E110-2LC-0138

<Date> June 25, 2014

Primary feed unit is changed as illustrated below for parts standardization purposes.

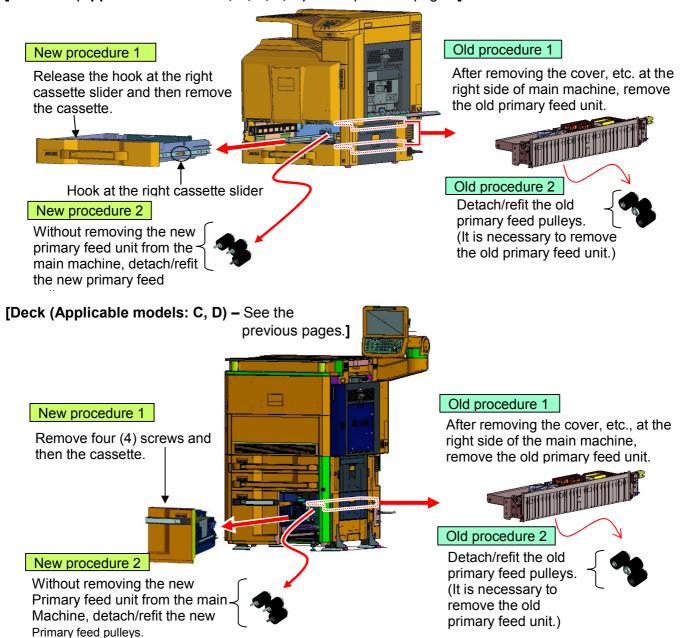
Although the primary feed unit for No. 7 and No. 10 is both identical and new-type, No. 10 is replaced by No. 7 for the parts standardization purposes with the TASKalfa 3551ci series.

*3: Primary feed pulley set for the field (One each of feed pulley, forwarding pulley and separation pulley are bundled) – Please use a set of old or new parts for No. 12 ~ No. 15.
